Re: Technical Deficiencies Related to Division Order Item #8, Bear Canyon Mine,  
Co-Op Mining Company ACT/015/025, Emery County, Utah

## **TECHNICAL REVIEW**

BEAR CANYON PLATE 2-1

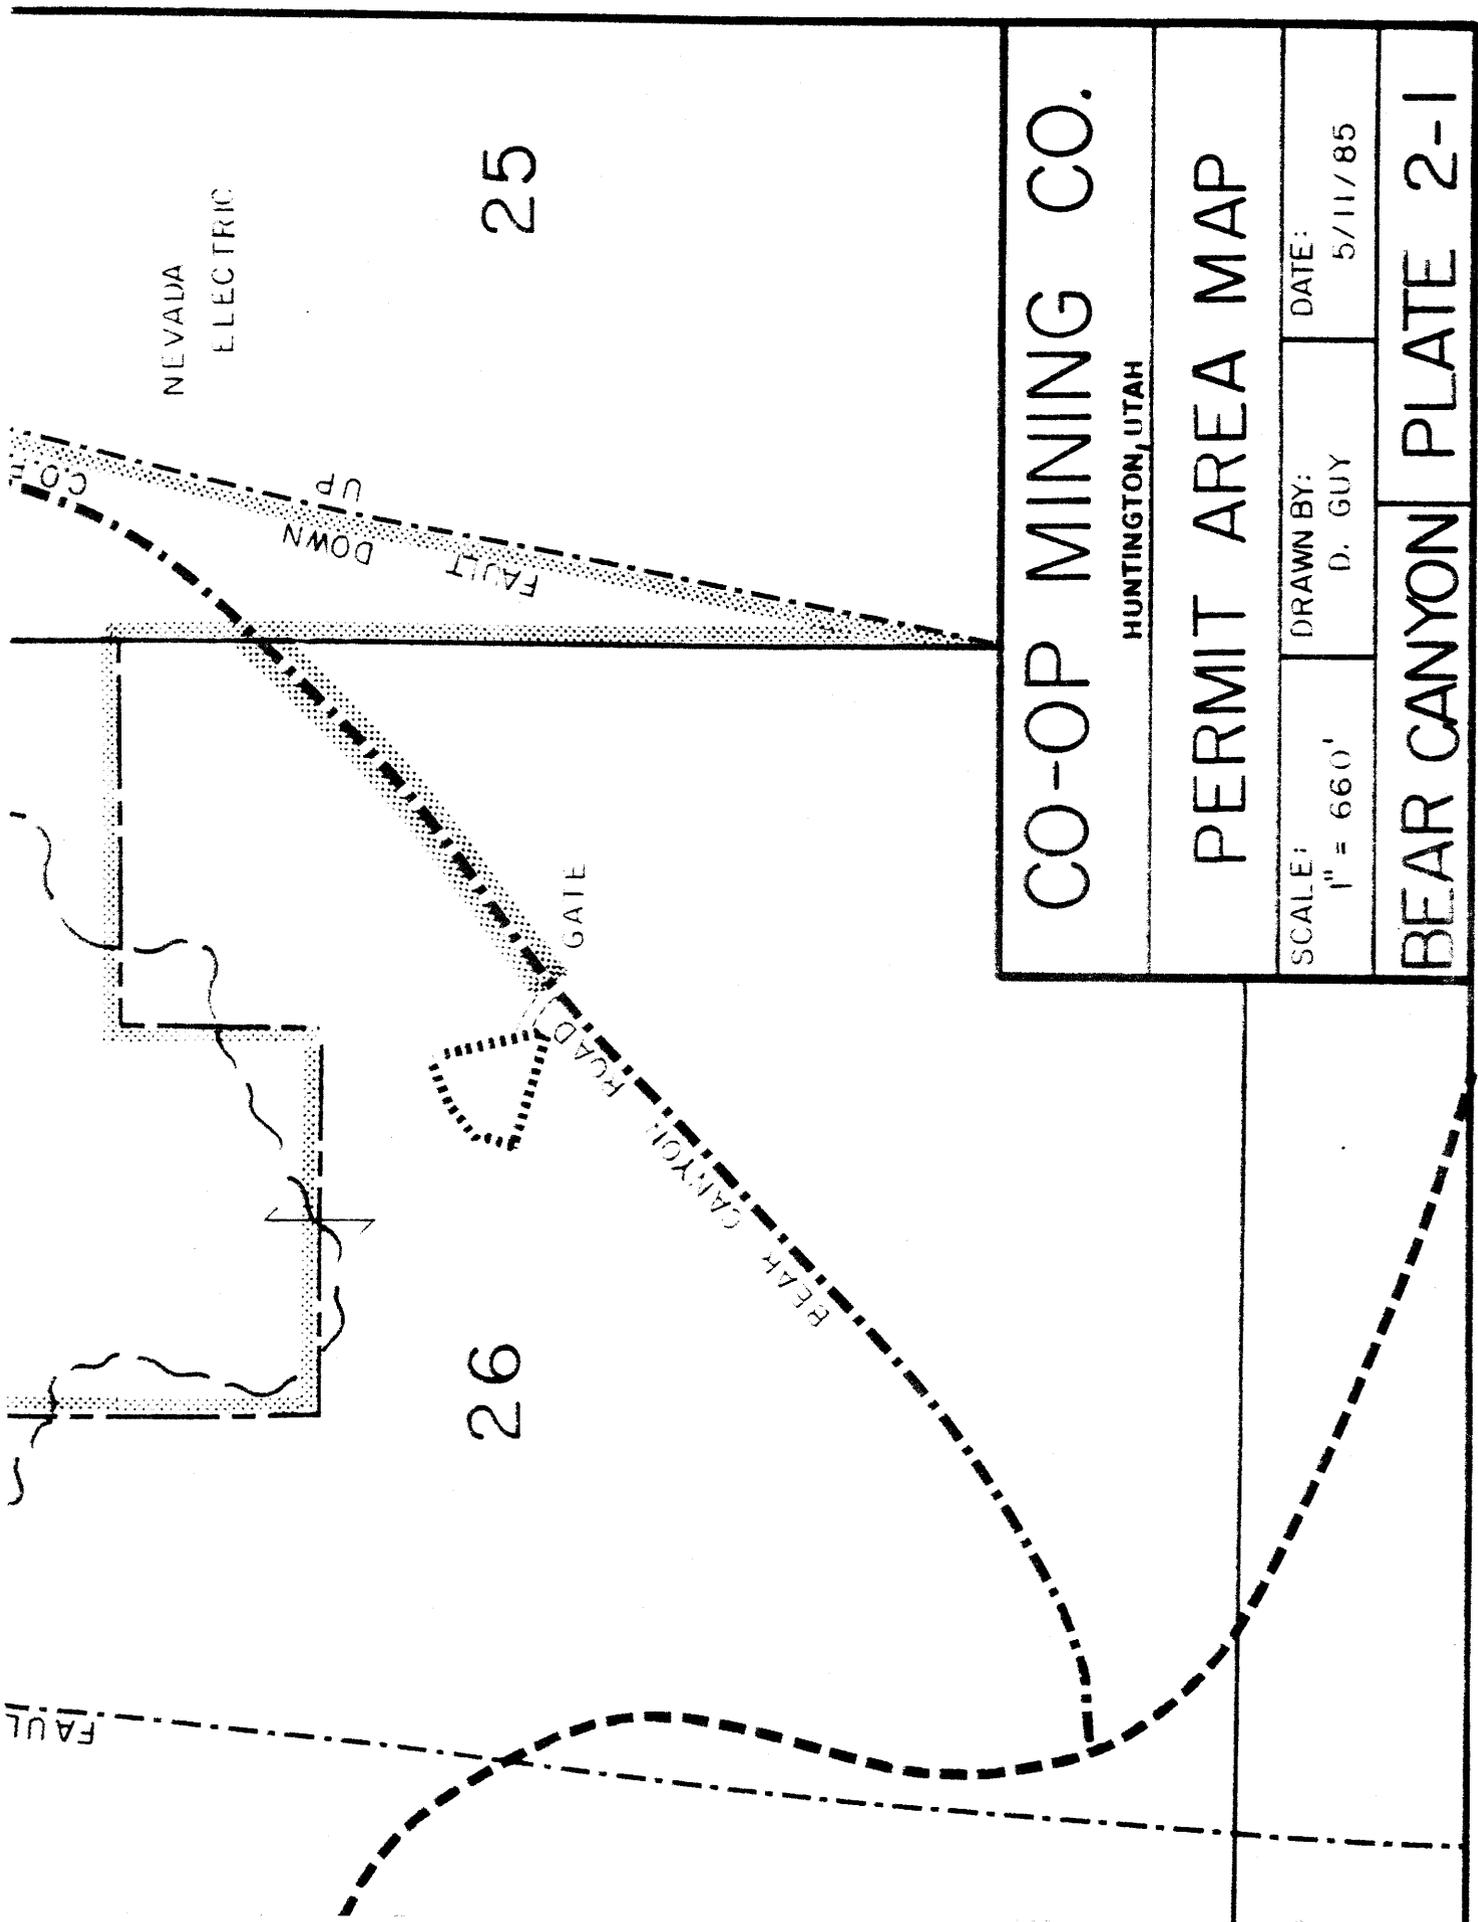
Attached is partial copy of Plate 2-1 from 1985. I propose that the access road was erroneously added to the permit area at some time in the past and that the corrections made are proper. The ball park topsoil pile has always been an island and not connected to the main permit area. The access road is used for recreation and not mining purposes. The present and post-mining use for both the ballpark (topsoil storage pile) and adjacent area is for recreation. The access road will only be used in association with mining activities during reclamation. No reclamation or changes to this road have been proposed by Co-Op Mining Co. nor recommended by the Division.
